# 高通硬件基带技术期刊2016-1-5

Revision	Date	Description
Α	Jan 2016	Initial release

#### MDM9X07 原理图更新

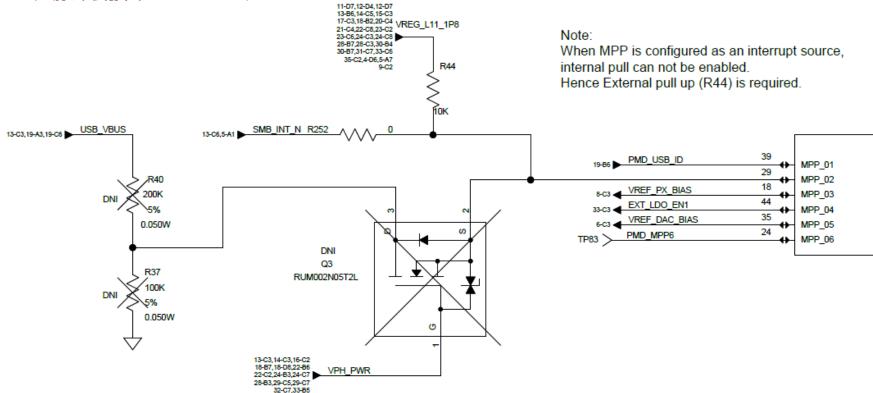
MDM9X07 原理图已经更新到C版本,修正了I2S MCLK bug 问题。

I2S\_MCLK is **not** routed to pad # AA3 as provided in 80-P1511-1 Rev B

It has to be routed through pin AD02. This impacts only projects that use audio functionality. If I2S MCLK is needed, above modification in schematic should be done.

SW CR 939754 needs to be incorporated to ensure I2S\_MCLK is available on pin AD02.

#### PMIC - PMI8996/PMI8994 SCHG layout guideline 更新

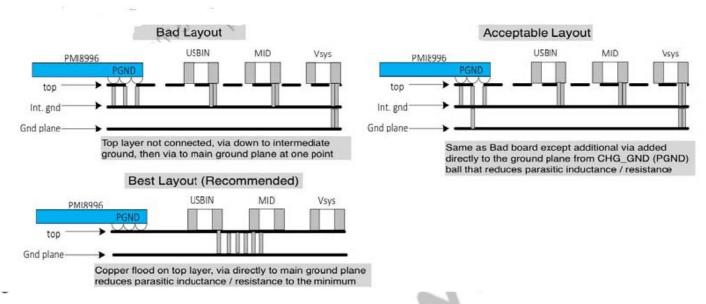
♪ 问题描述:PMI8996 可能会在闪光的时候烧掉。

□ 推荐方案:80-NJ117-5 rev G, 81, 82页, 更新了layout guideline 如下图, 80-NJ118-4 rev K 更新了

Issue 7-8:

• Connect the GND of the charger input capacitors, output capacitor, and GND\_CHG pins of PMIC together on the top layers. Connect the common point directly to the main GND using multiple vias. This is to ensure that the parasitic inductance and resistance in the charger ground path is reduced as much as possible. In the event that the layout guidelines cannot be entirely met due to routing constraints, it is recommended to add one or more vias on CHG\_GND directly to the main GND, as shown in the figure in the next slide.
